Our Reference: **PT17063**

**United Cinema Complex Gregory Hills
Request for Additional Information Response**

As requested we have reviewed the request for additional information from Camden Council dated 23 April 2018 and please find below information pertaining to each issue relating to traffic, parking and access matters.

1 SITE PLAN
SCALE 1:500

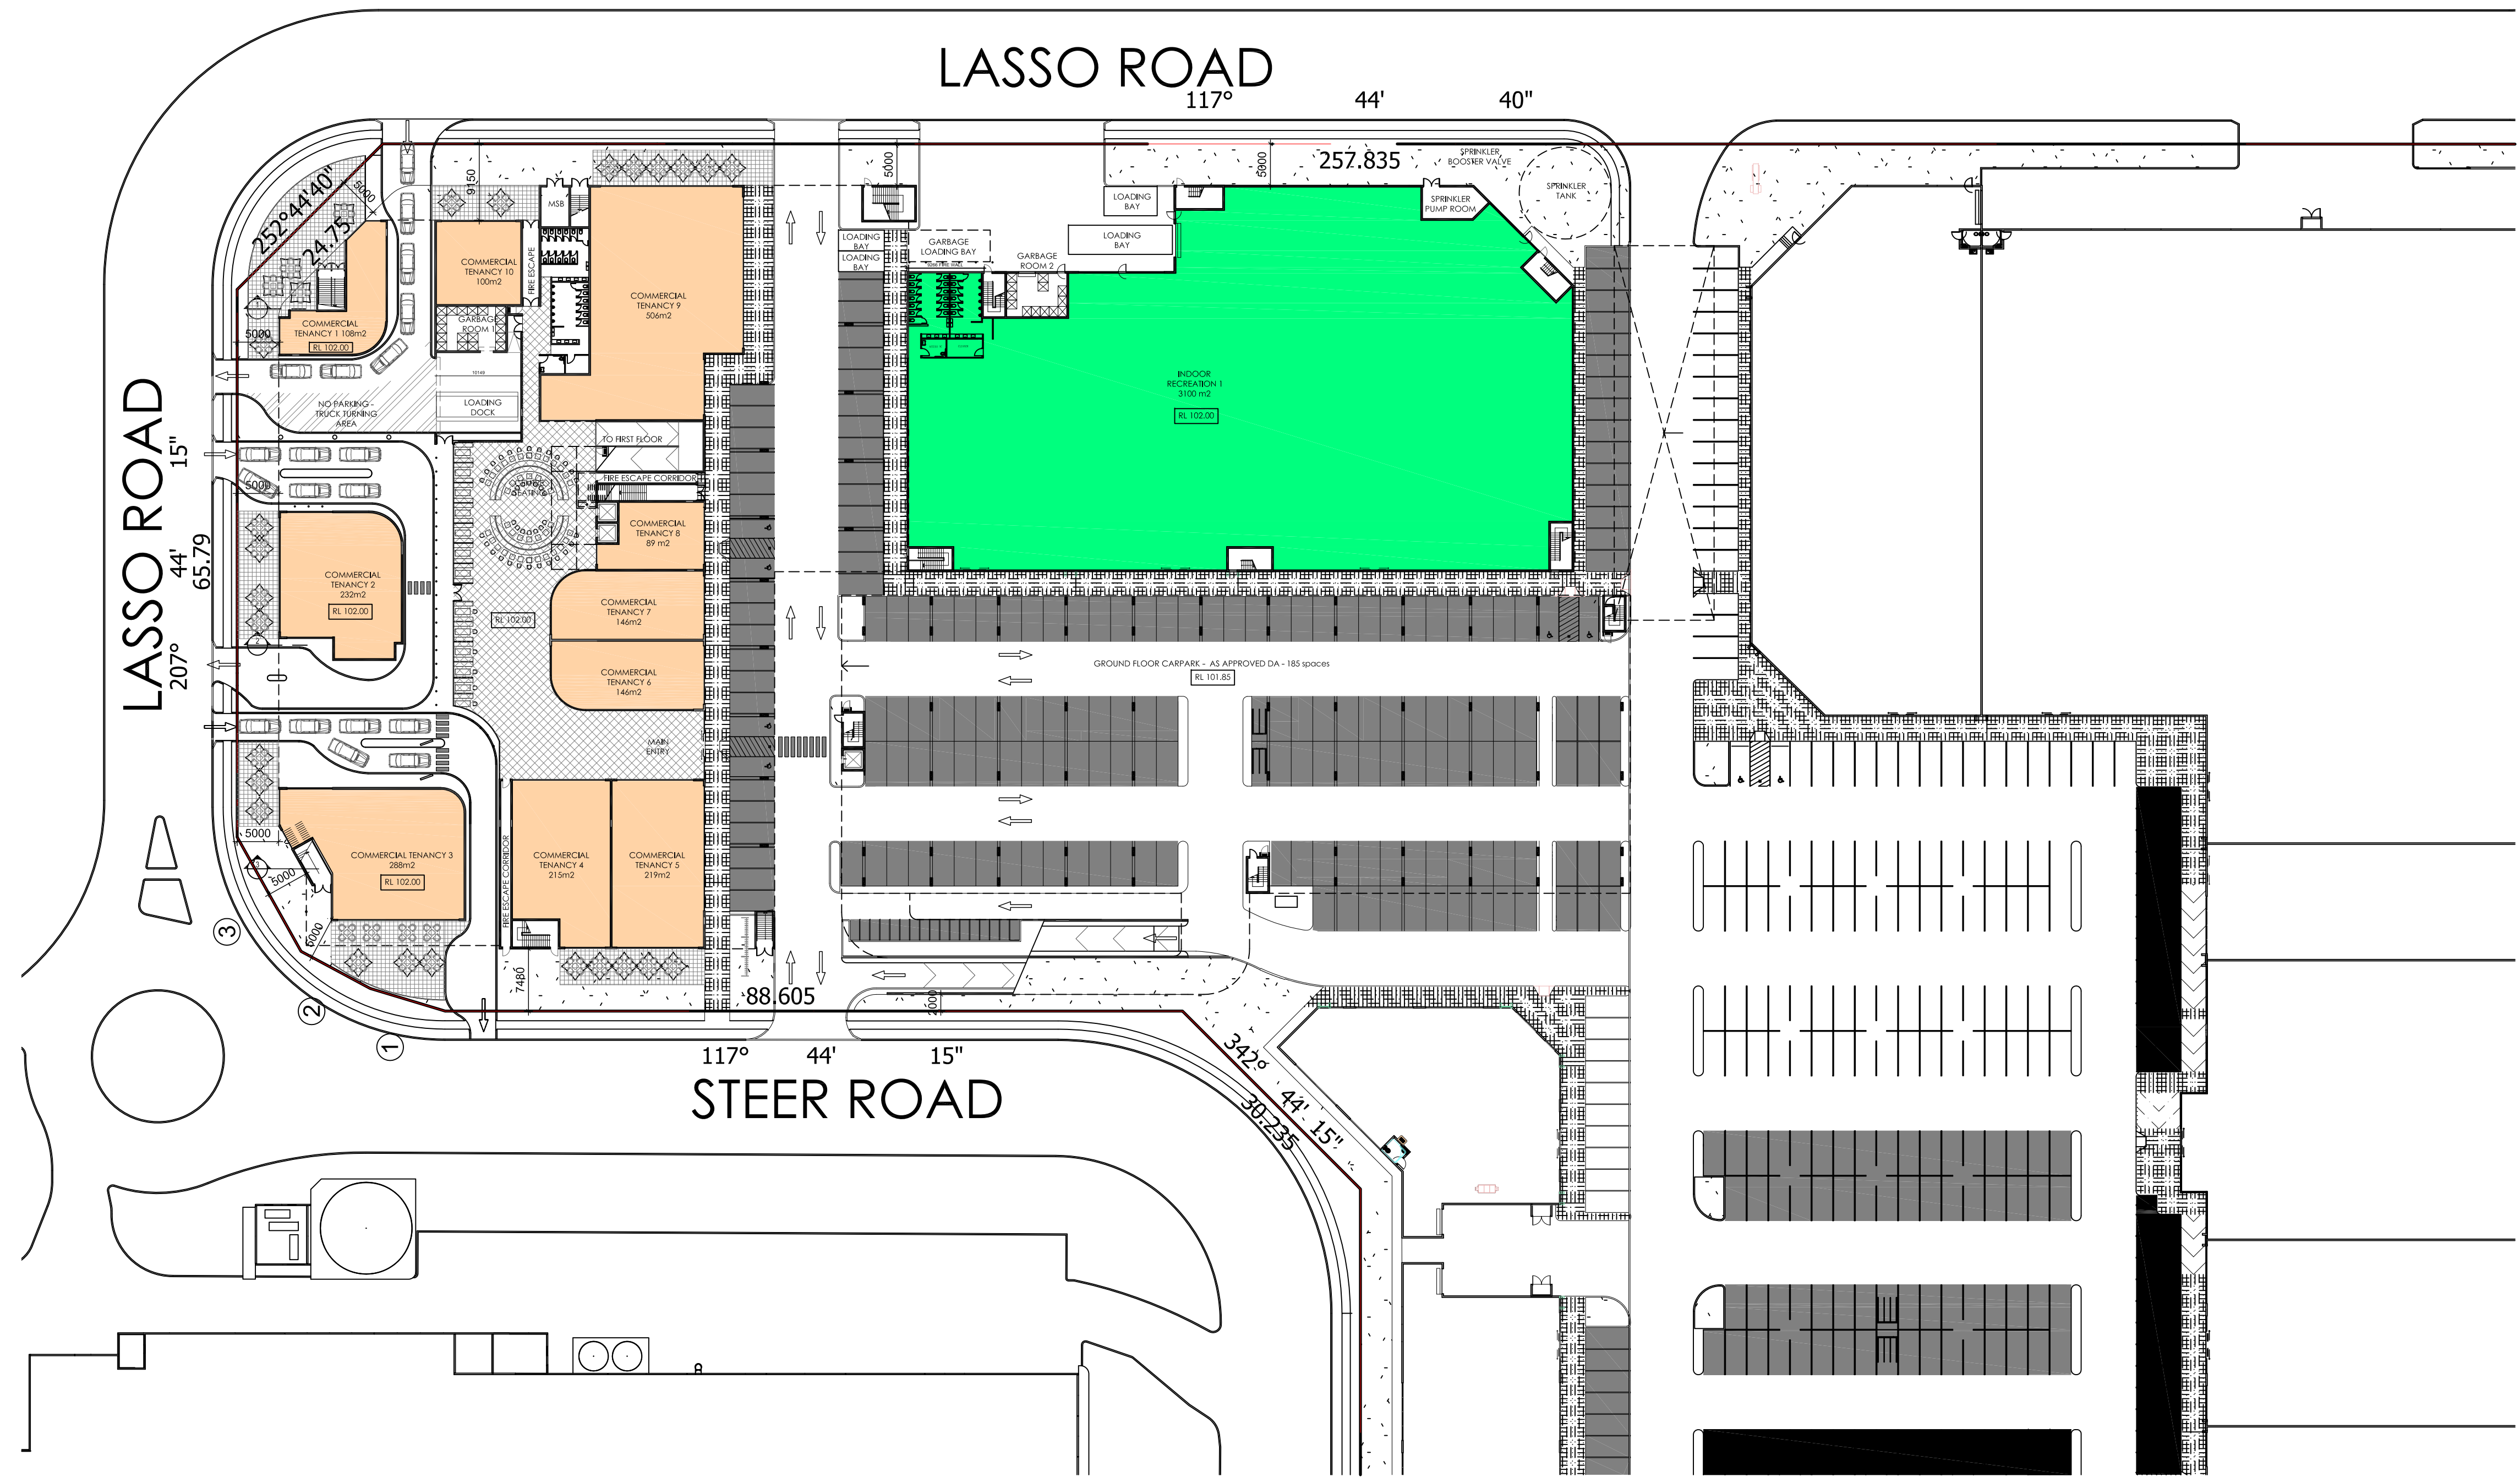
5. The loading dock within the driveway to tenancy 1 conflicts with customers accessing the drive through and could lead to safety issues and queuing of vehicles on the road. Please address.

12. Queuing for 5-12 cars must be identified on the plans for the three take away food and drink premises.

15. The traffic report identifies that there should be an additional four external seats which are not identified on the plans. Please address.

In response to Council comments the design of the loading dock and adjacent drive thru access road has been modified to ensure both light and heavy vehicle travel in the same direction. Further, all reversing of the service vehicle is undertaken from an area separate to the main flow of traffic in the drive thru lane.

The proposed arrangements provide sufficient queuing area for a minimum of five (5) vehicles which complies with the requirements of the DCP.

The revised plans provided in **Appendix A** confirm that all drive thru developments would provide a minimum queue area to allow five (5) vehicles to queue wholly within the property of each development.

The revised plans provided in **Appendix A** confirm that the plans reflect the correct number of seats estimated in the traffic report.
